## ADDENDUM NO. 3

To: All Plan Holders of Record and Interested Parties  
Project: Clinton County Administration Building - Addition & Alterations  
Project No.: 22072  
Issue Date: March 5<sup>th</sup>, 2024  
Bids Due: 2:00 PM, March 13, 2024

**GROUND FLOOR  
MECHANICAL  
PIPING PLAN**

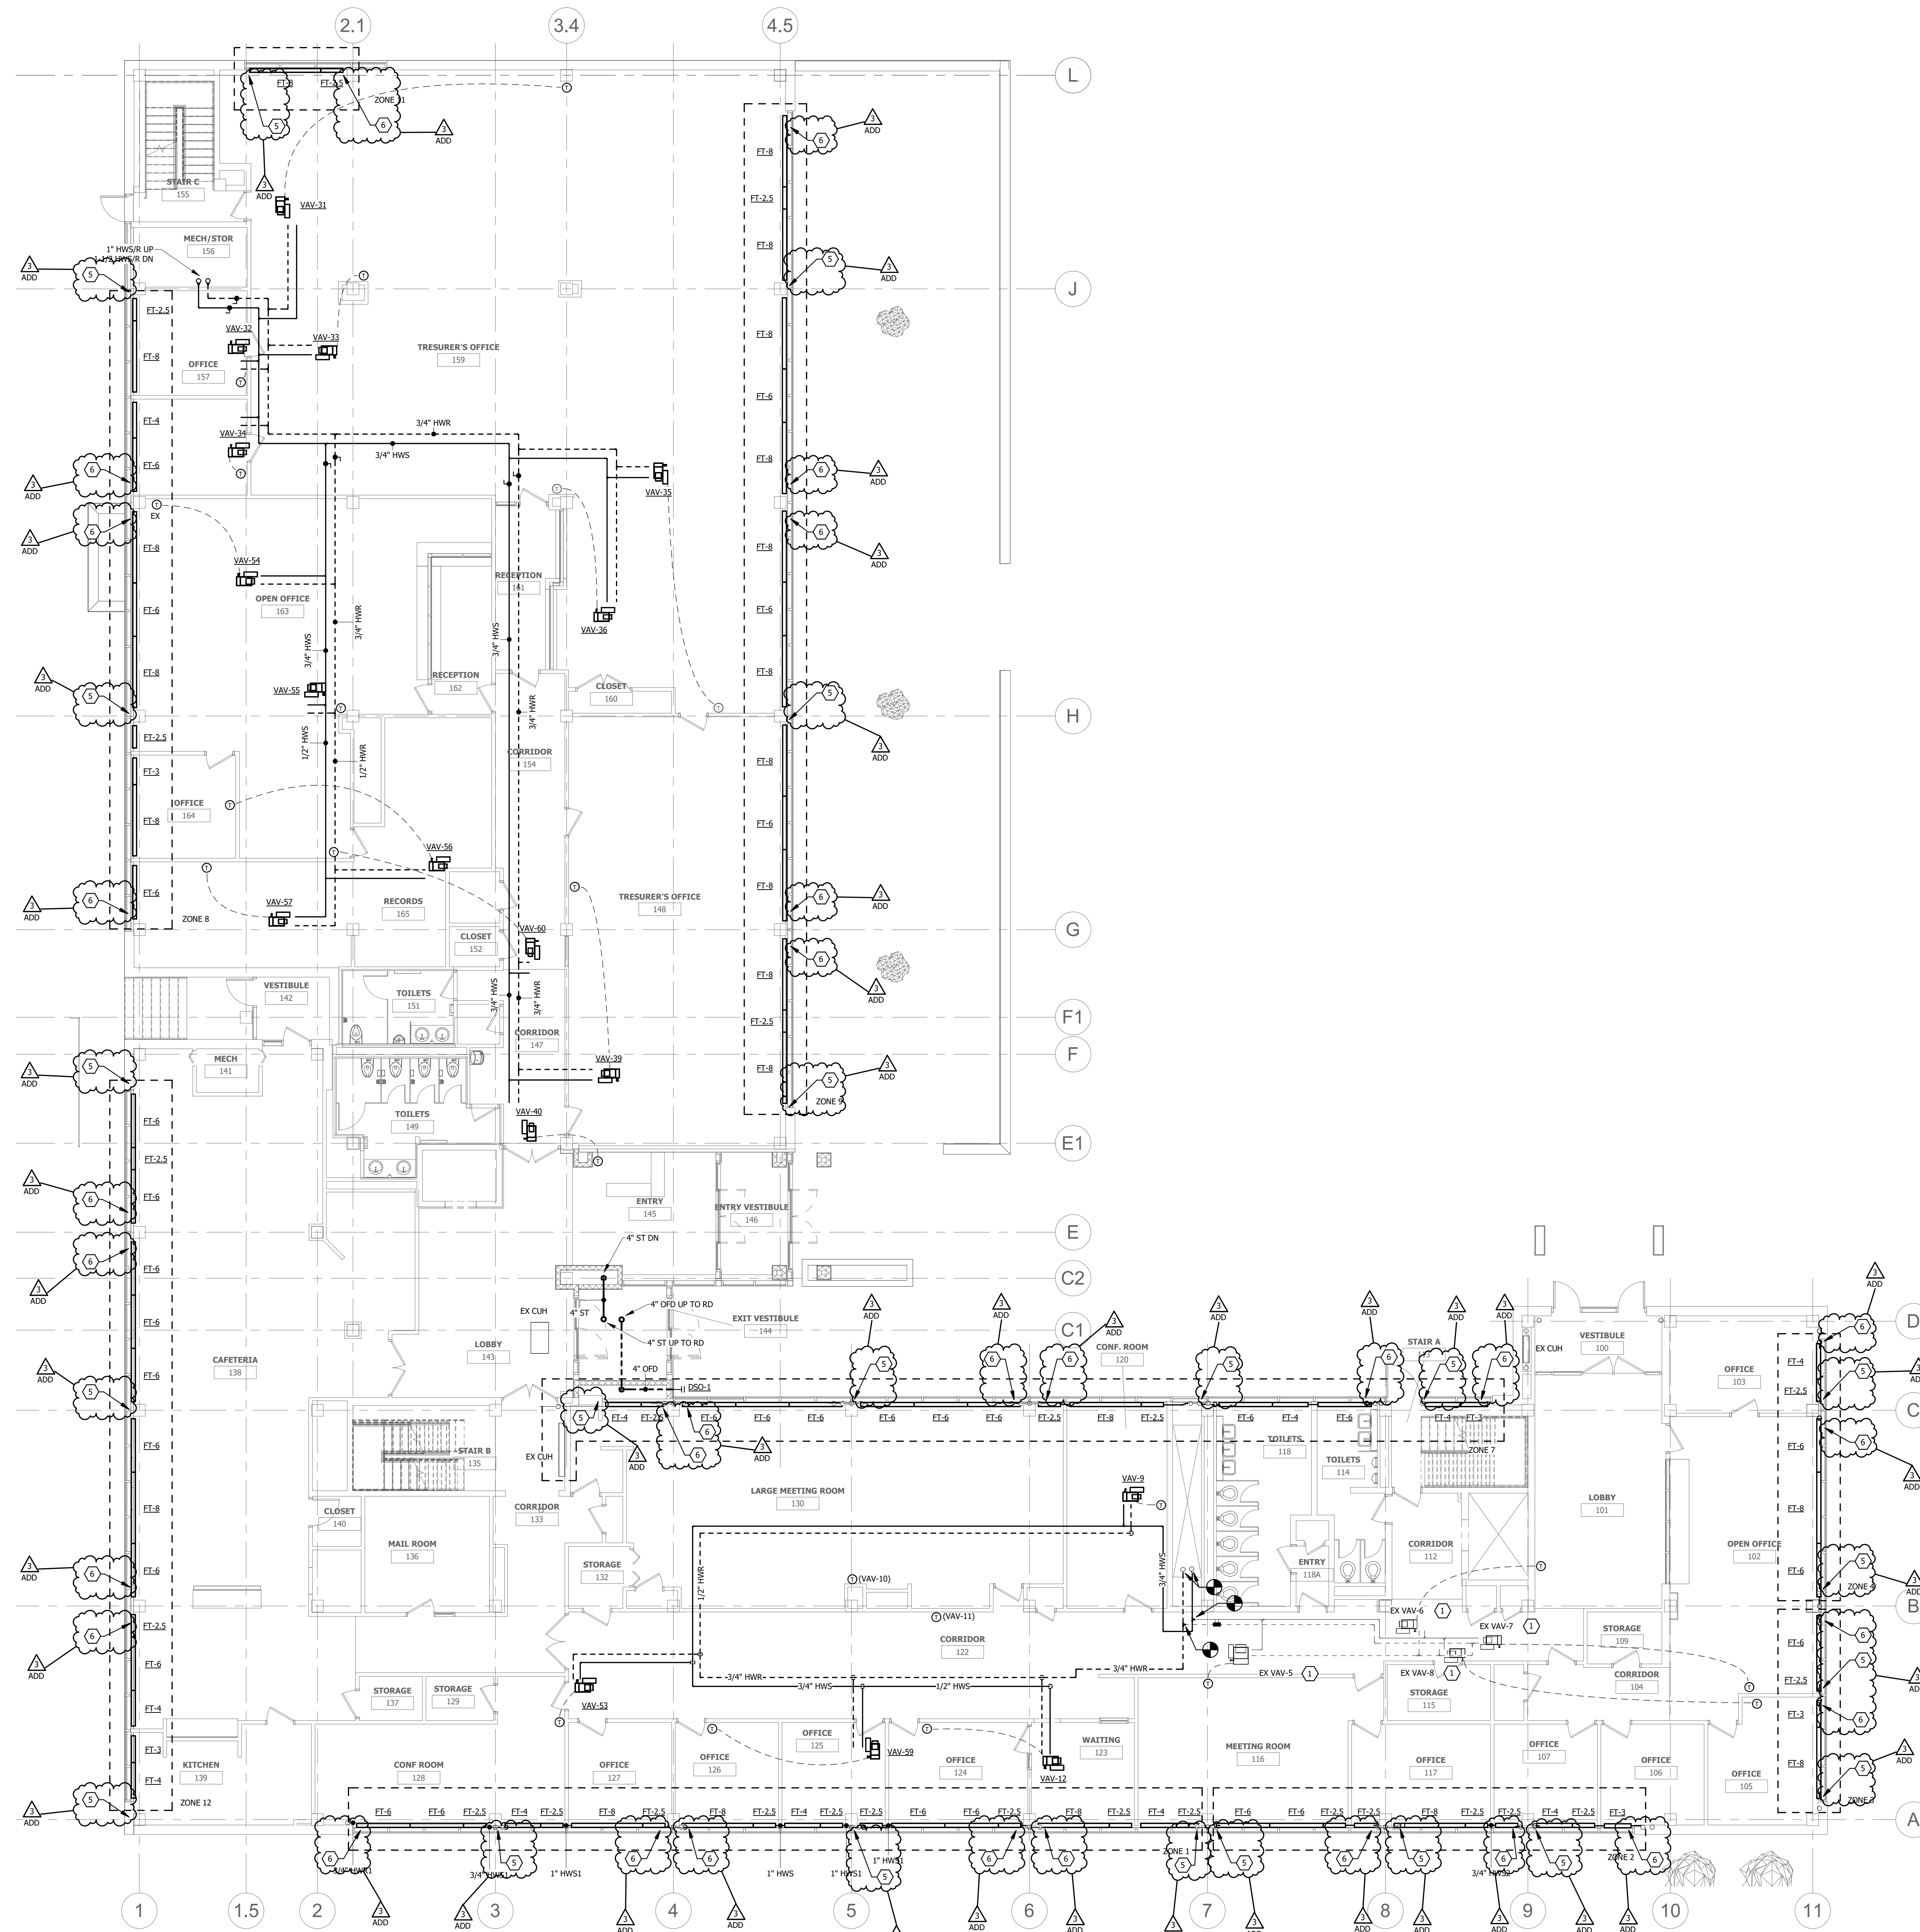
1. Referenced Mechanical Notes
  - A. **ADD** Note 5 to read: "Connect adjacent fin tube runs to existing hot water supply riser. See detail on sheet M501."
  - B. **ADD** Note 6 to read: "CONNECT FIN TUBE RUN TO EXISTING HOT WATER RETURN RISER. PROVIDE AND INSTALL ONE (1) SET OF HYDRONIC SPECIALTIES IN LAST FIN TUBE ENCLOSURE BEFORE RISER. SEE DETAIL ON SHEET M501."
2. Ground Floor Mechanical Plan
  - A. **ADD** Note 6 to end of fin tube runs where they connect to the return risers. See reissued sheet for more details.
  - B. **ADD** Connect to existing symbol to hot water supply for fin tube run. See reissued sheet for more details.

M201

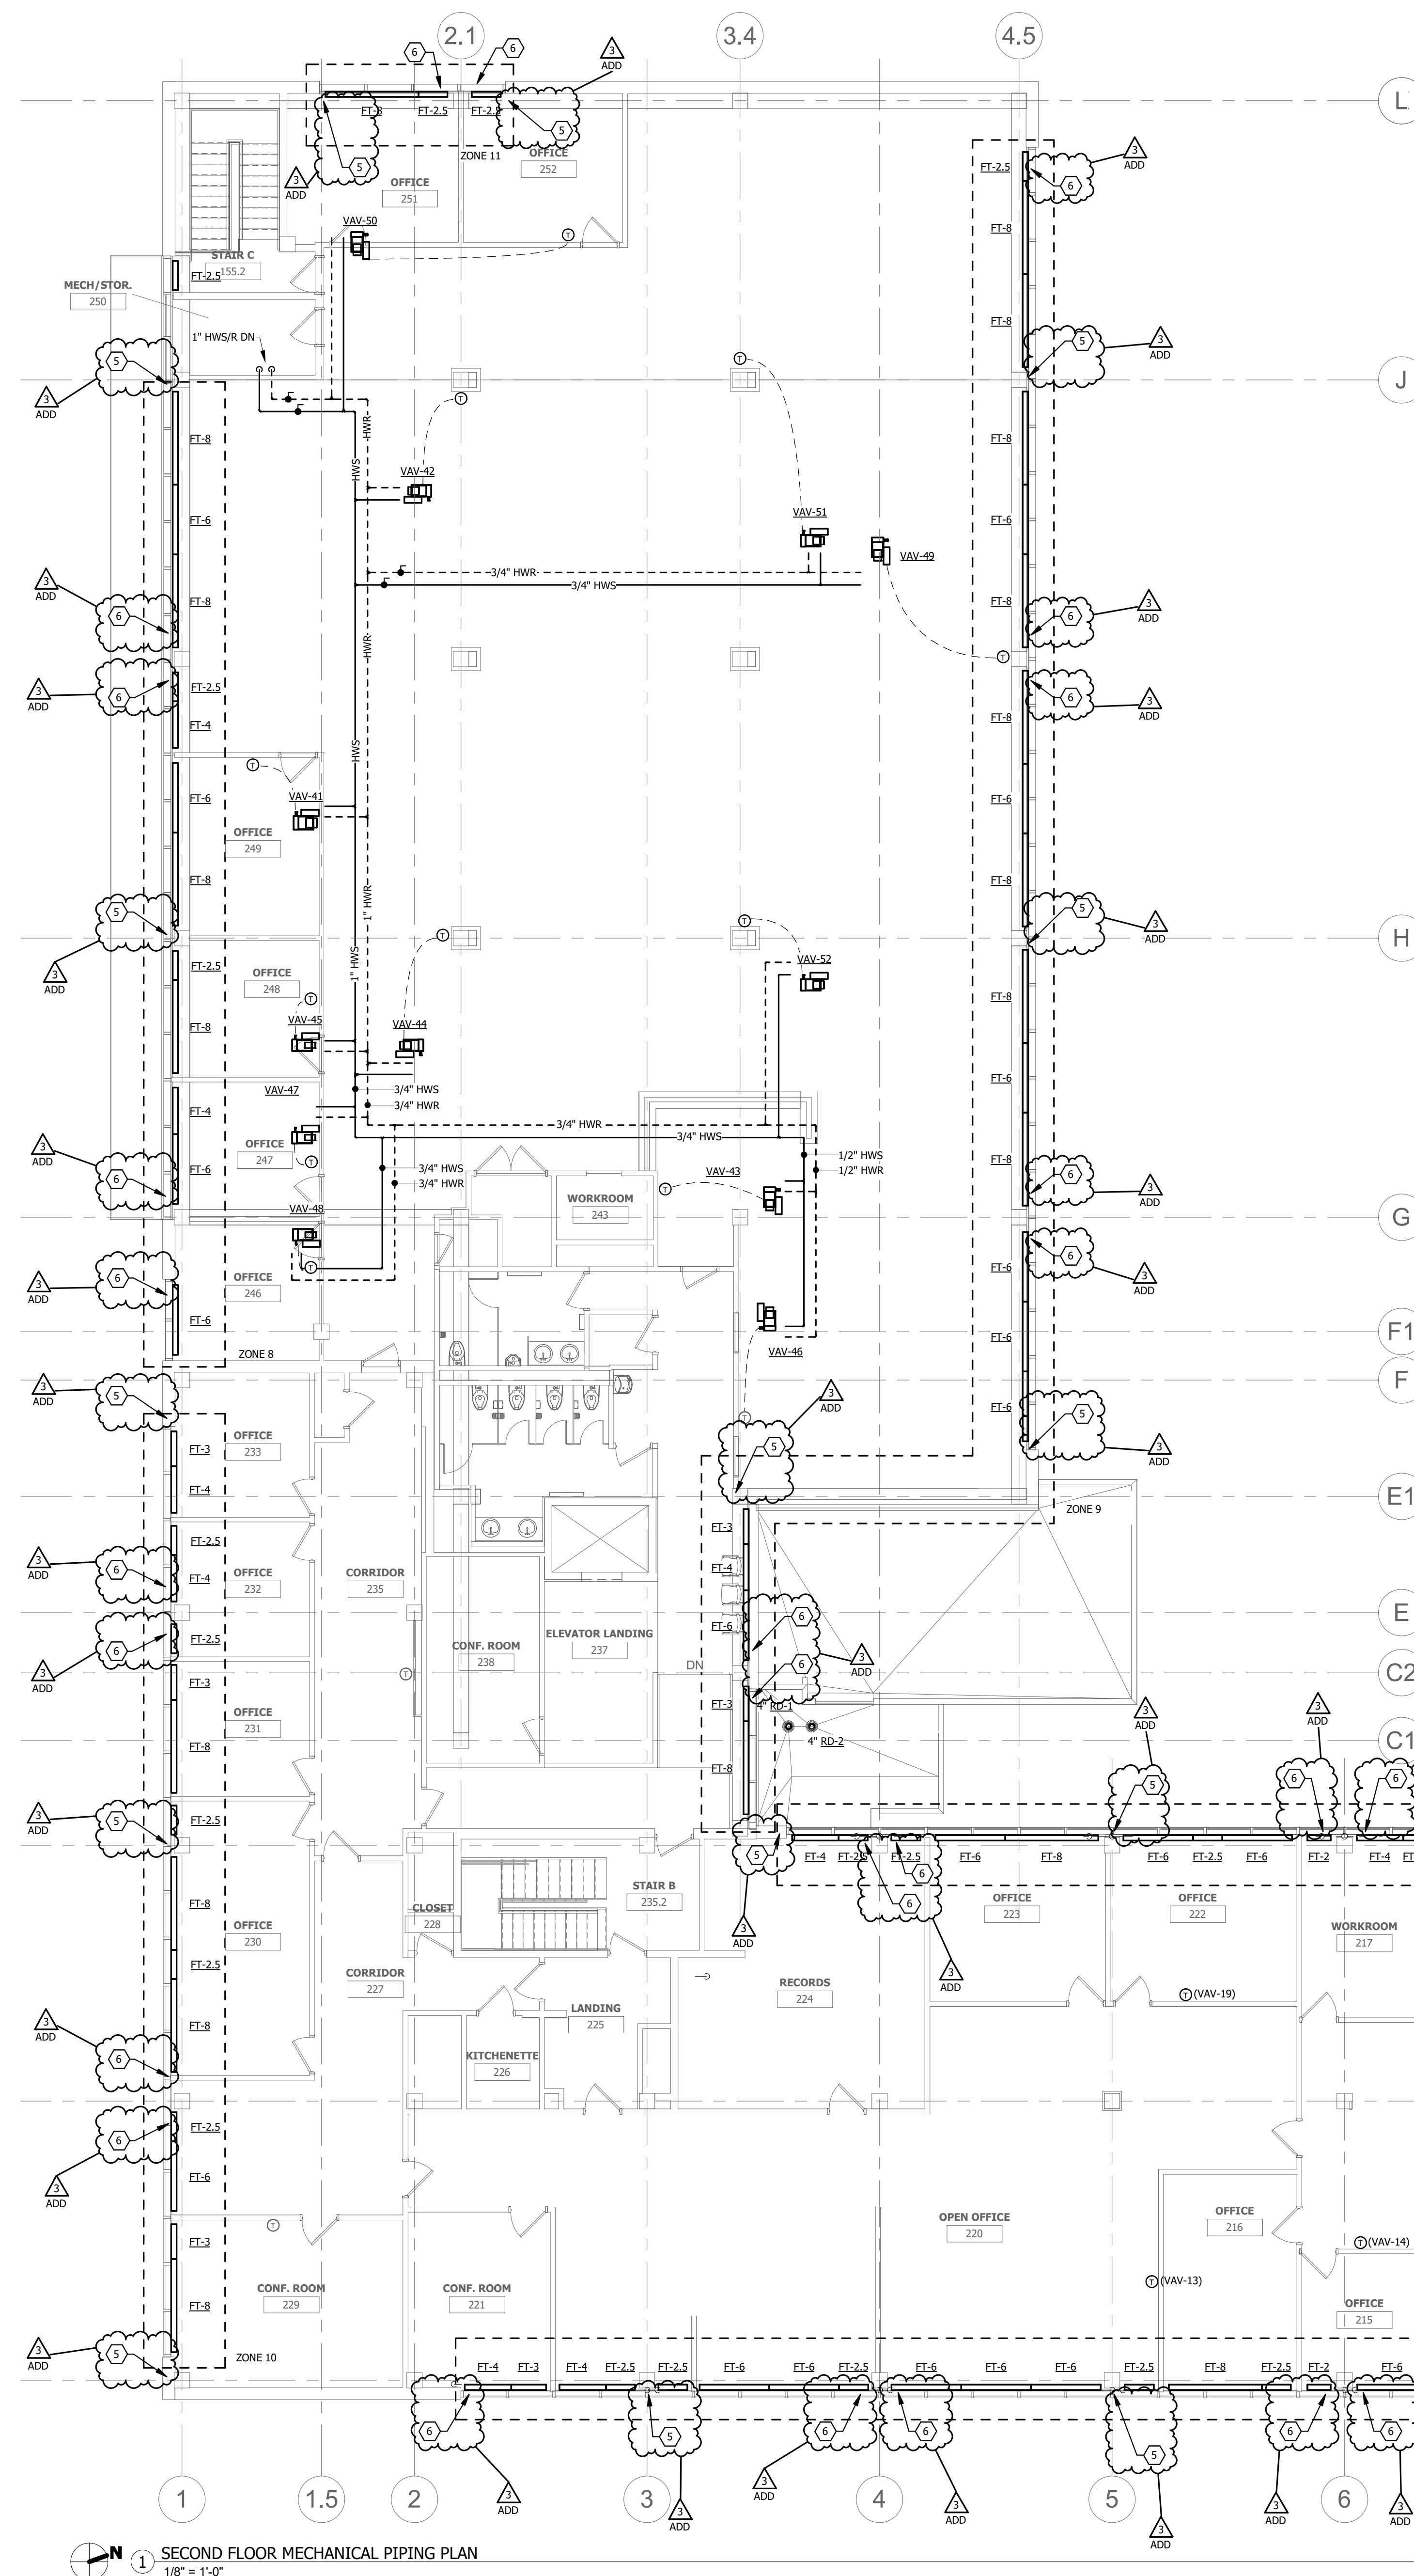
1. Referenced Mechanical Notes
  - A. **ADD** Note 5 to read: "Connect adjacent fin tube runs to existing hot water supply riser. See detail on sheet M501."

- B. **ADD** Note 6 to read: "CONNECT FIN TUBE RUN TO EXISTING HOT WATER RETURN RISER. PROVIDE AND INSTALL ONE (1) SET OF HYDRONIC SPECIALTIES IN LAST FIN TUBE ENCLOSURE BEFORE RISER. SEE DETAIL ON SHEET M501."
- 2. First Floor Mechanical Plan
  - A. **ADD** Note 5 to hot water supply riser locations. See reissued sheet for more details.
  - B. **ADD** Note 6 to end of fin tube runs where they connect to the return risers. See reissued sheet for more details.
